Subject: City of Edcouch, Texas  
Domestic Wastewater Treatment Plant Buffer Zone Compliance

EDCOUCH - BUFFER ZONE MAP

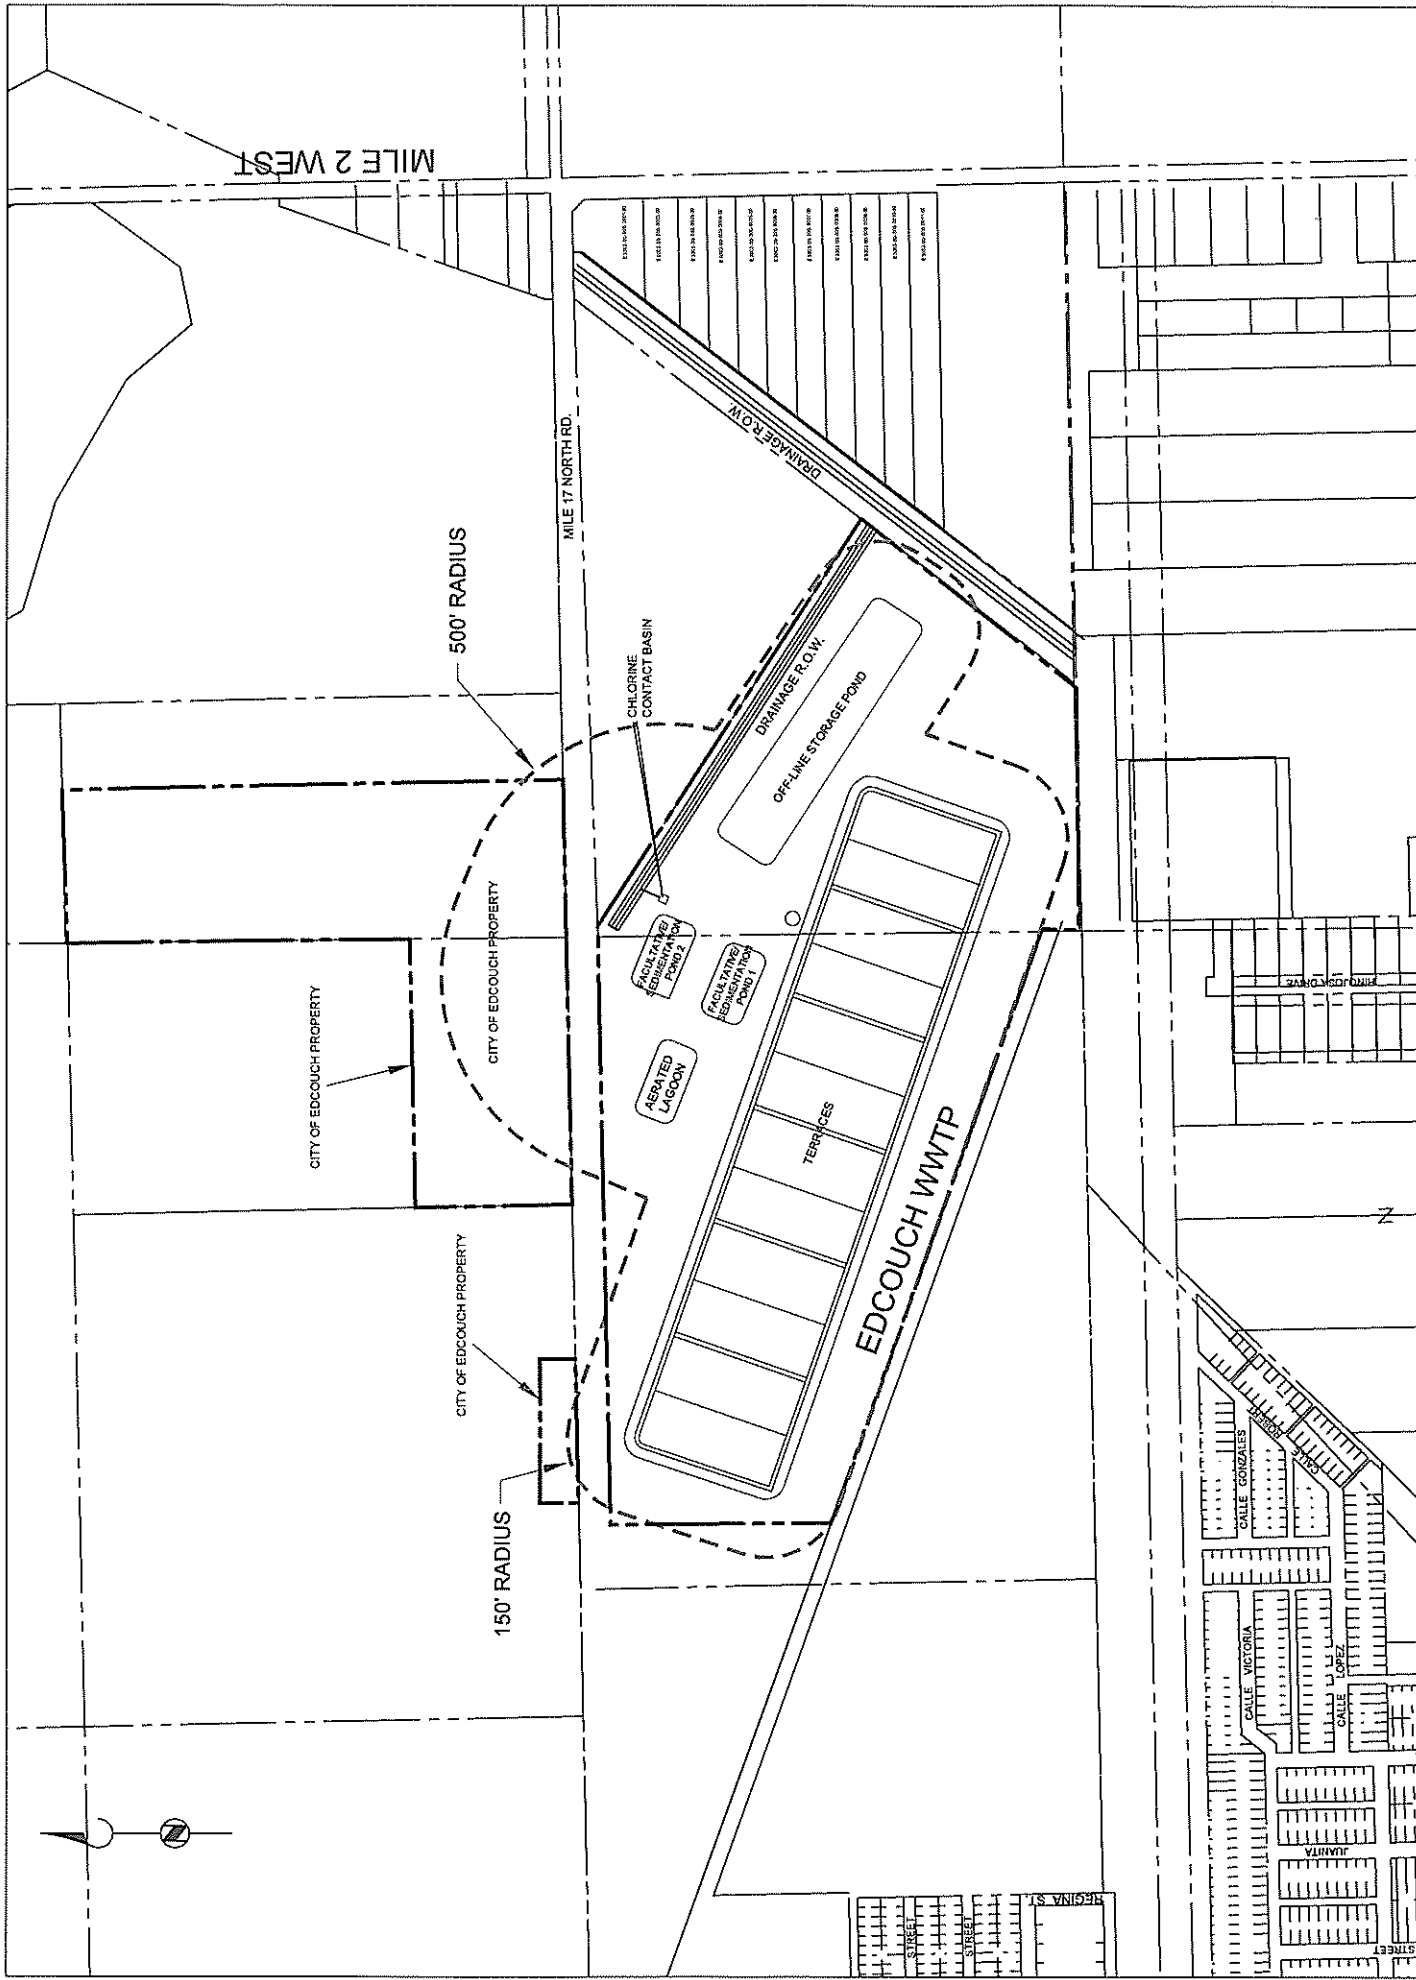
Commissioners Court will have to consider.

According to the engineer it will not affect the road at all, but they need to make sure no permanent building is placed on that buffer zone which includes the road area.

Jose....I have read the regulations but I still do not understand why they need the road. Please explain.
